**Subject: Response Letter for Revised Final Basis of Design – Mid-Plume Pump and Treat System, Kirtland Air Force Base Bulk Fuel Facility, New Mexico**

### **Revised Final Basis of Design, Mid-Plume Pump and Treat System**

**Subject: Revised Final Basis of Design – Mid-Plume Pump and Treat System, Kirtland Air Force Base Bulk Fuel Facility, New Mexico**

| CLIENT DWG NO:                             |                                 | FIGURE 2 – PROCESS FLOW DIAGRAM<br>BASIS OF DESIGN SUBMITTAL<br>PHASE IV MID-PLUME PUMP & TREAT SYSTEM |  |

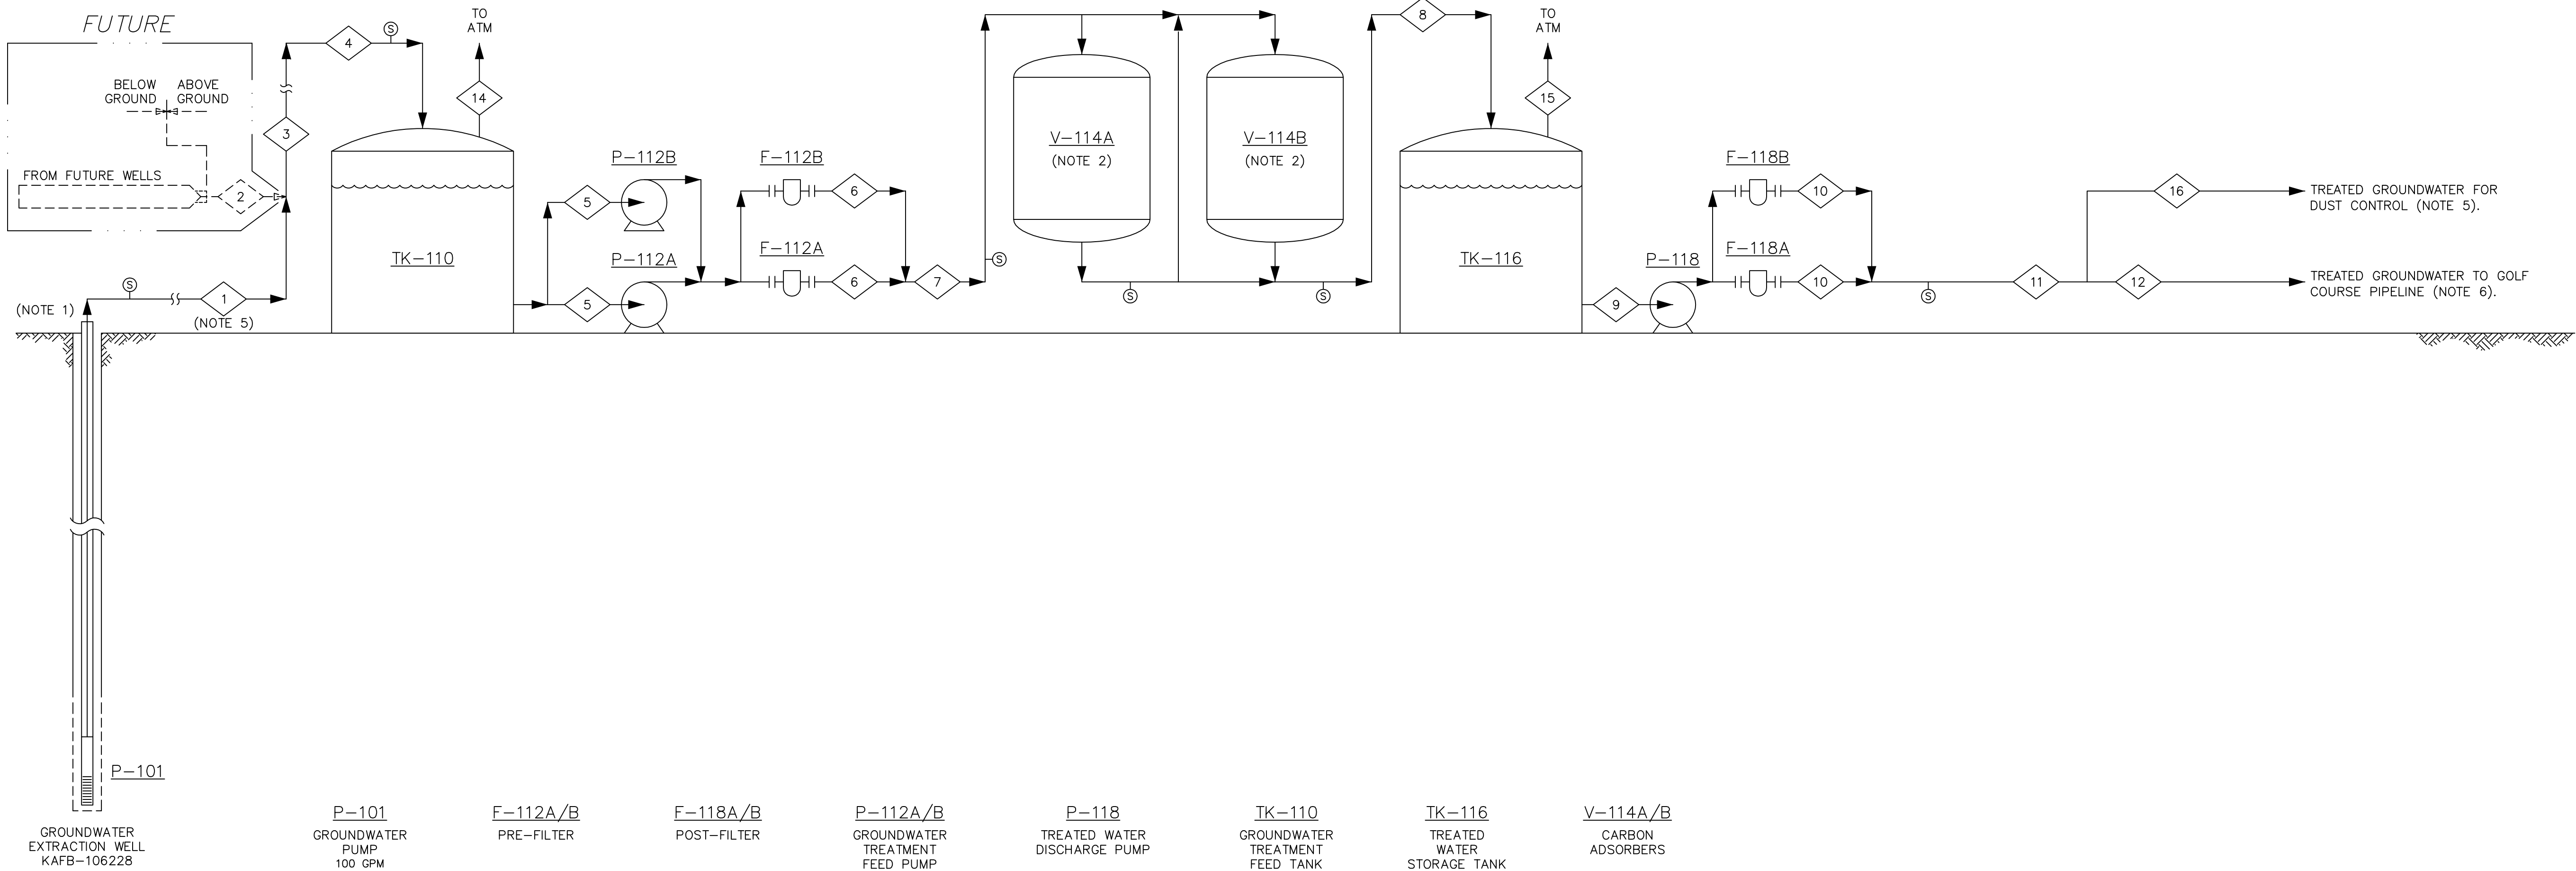
- a) The locations of sampling ports within the carbon treatment system, and a revised Figure 2 Process Flow Diagram that denotes the sampling ports.*
- b) The capacity, outlet, and other details of the treatment building sump.*
- c) Pipeline integrity testing methods and results.*
- d) A list of the regulatory permits that were obtained.*
- e) A list of the regulatory construction inspections that were conducted.*
- f) Specifications on trenching, backfilling, compaction and vertical and horizontal infrastructure separation.*
- g) A revised Figure 3 that has labels for equipment layout.*
- h) Figures depicting a typical trench detail, road crossings, manifold details, and infiltration gallery plan and section details.*

- a) Drawings showing the sample ports are shown on Figure 2, “Process Flow Diagram” in the revised final BOD.
- b) The capacity, outlet, and details for the permanent treatment building sump will be included in the as-built report. The temporary treatment system does not have a sump.

| FIGURE 3 – EQUIPMENT LAYOUT<br>BASIS OF DESIGN<br>PHASE IV MID-PLUME PUMP & TREAT SYSTEM       |                                 |                   |

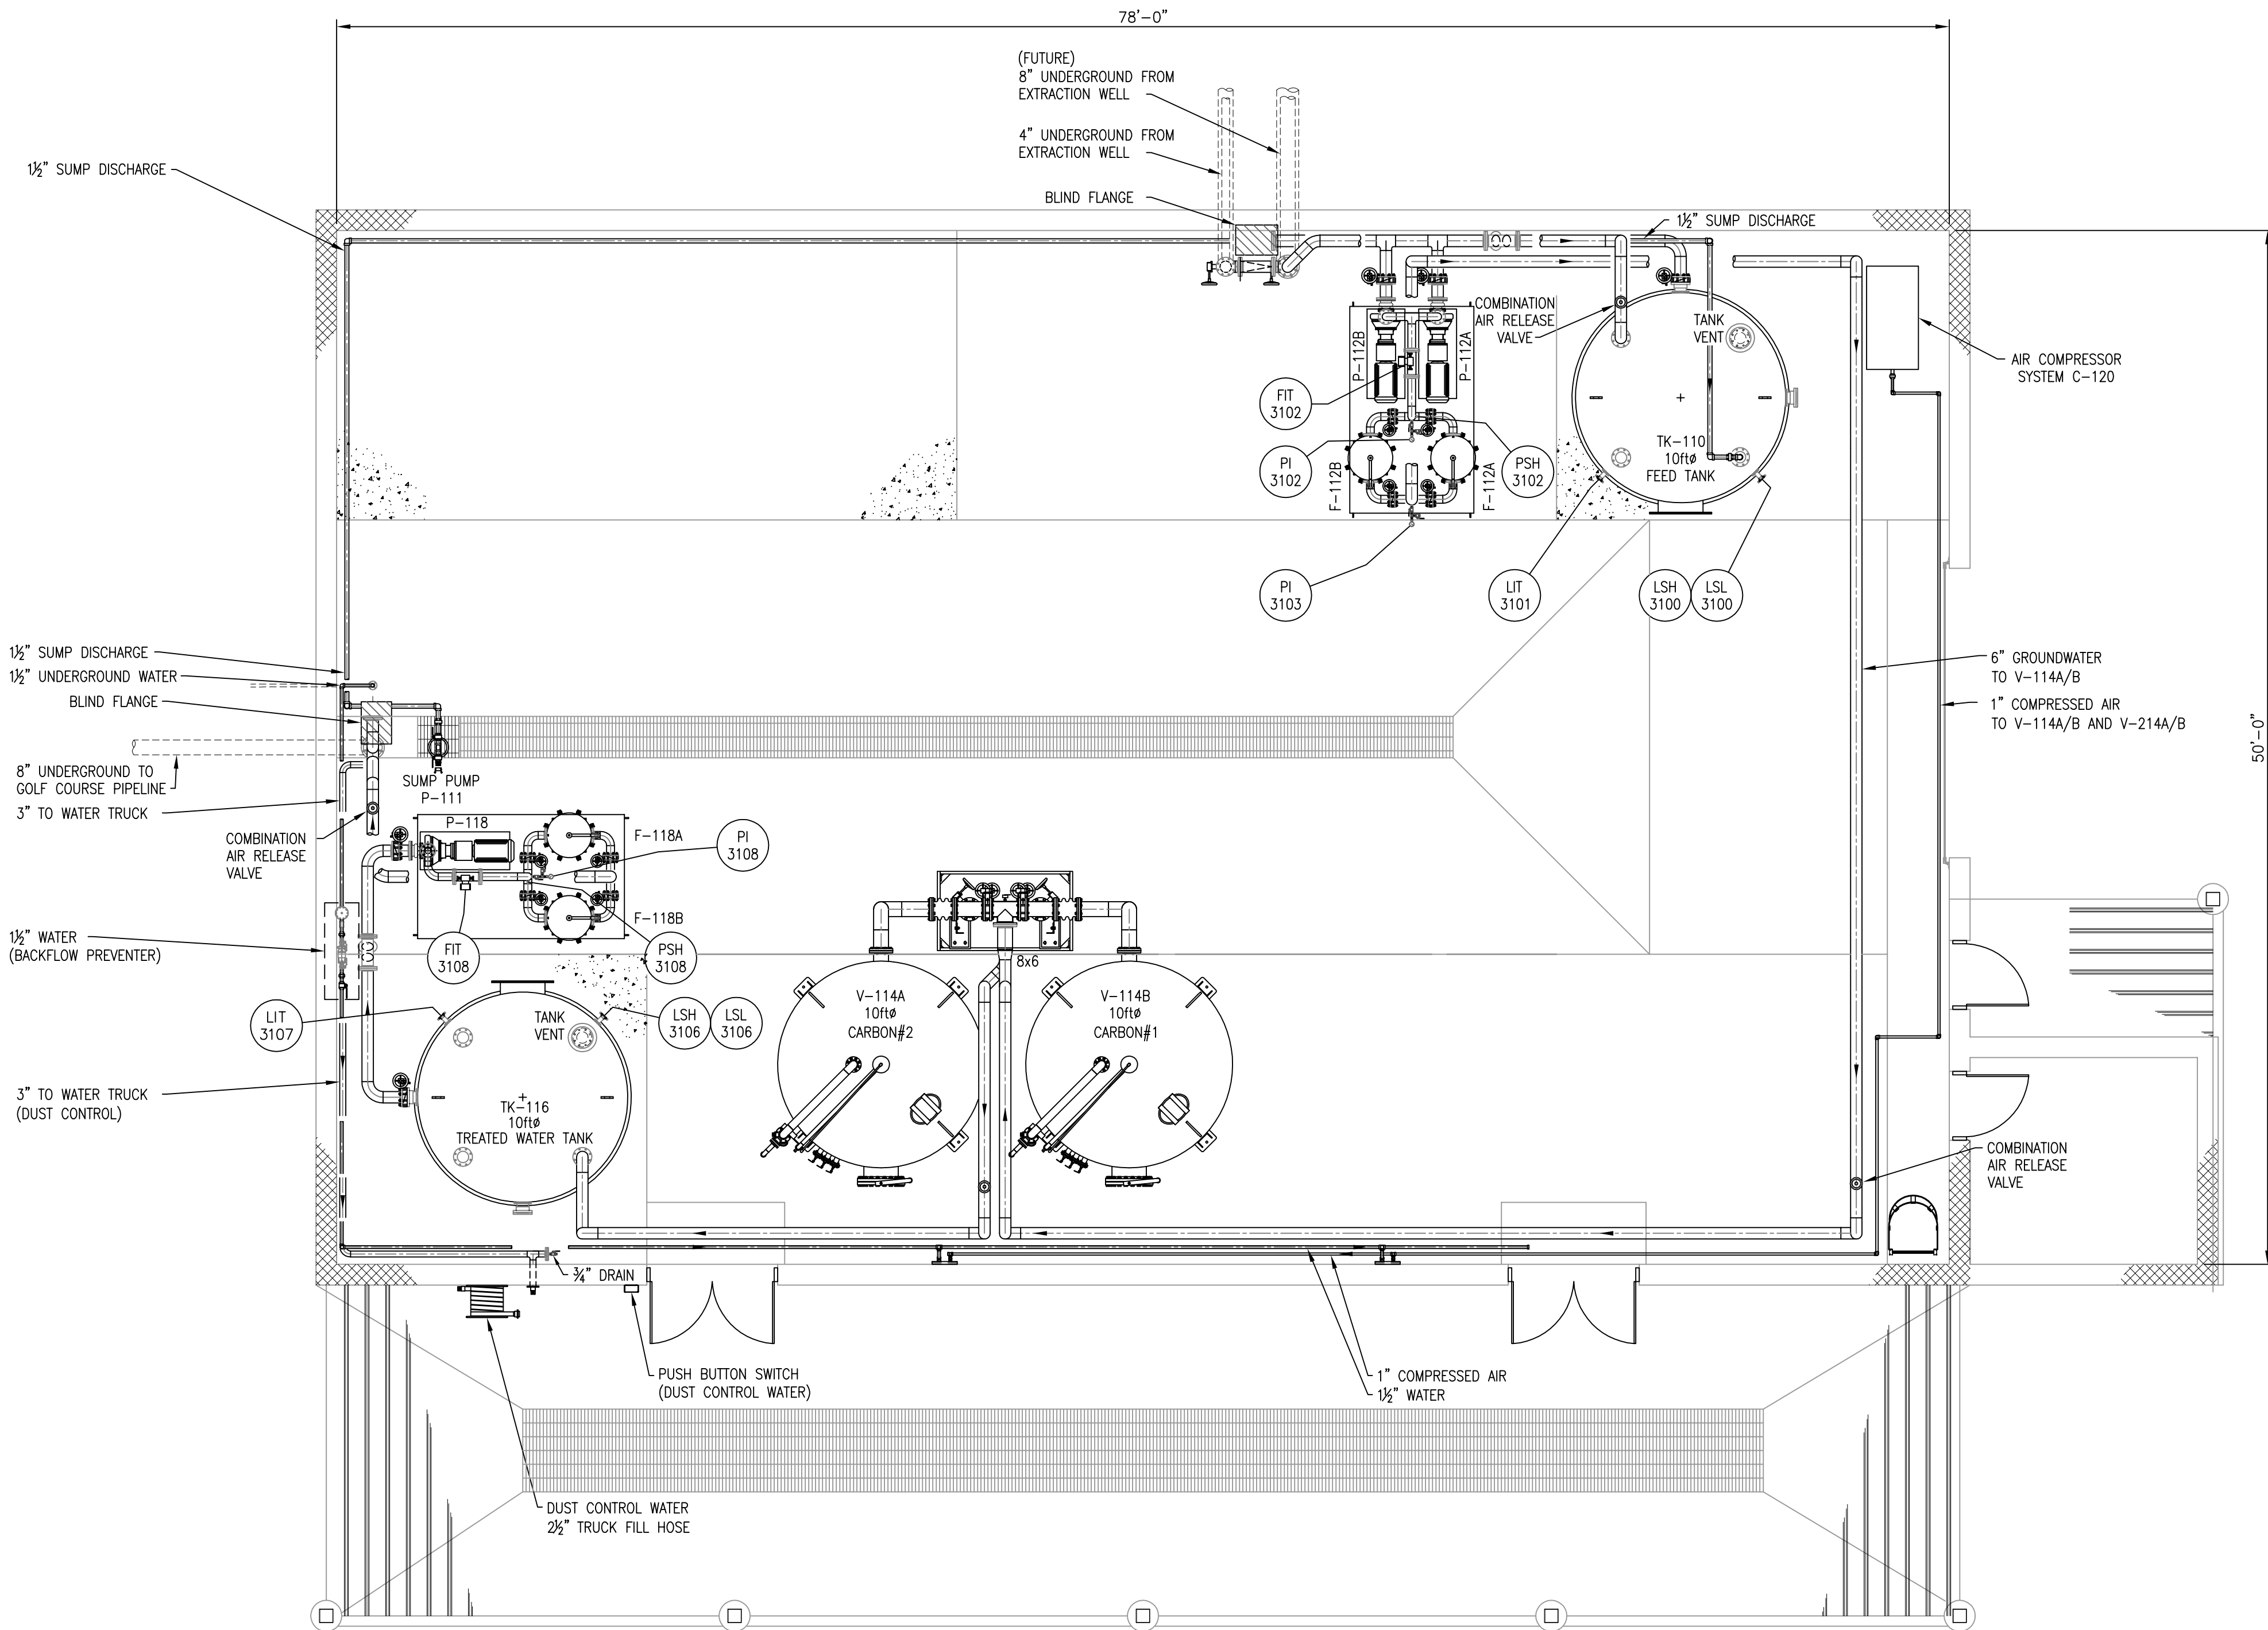
- i) Design basis and rationale, for infiltration gallery cell dimensions based on anticipated long-term infiltration acceptance rates.*
- j) Design basis for selection of underground and aboveground extraction water conveyance lines.*
- k) Design basis and supporting calculations for the selection of two 20,000 pound carbon treatment vessels and bag filter sizing.*
- l) Design basis and justification for the slab-on-grade/pavement design load.*
- m) Infiltration gallery piezometer specifications.*
- n) All relevant manufacturer cut sheets.*

- g) Figure 3 in the revised final BOD has been revised to include labels for the equipment layout.
- h) The revised Final BOD has been revised to remove any details and design of an infiltration trench; the temporary treatment system will discharge treated water to the main pond at the Tijeras Golf Course for irrigation. Plan and cross-section view drawings for road crossings, manifold details, and trenching will be included in the as-built report. The discharge for the permanent treatment system has not been finalized. When a decision is made on the discharge for the permanent treatment system, Kirtland AFB will provide the design to NMED for review.
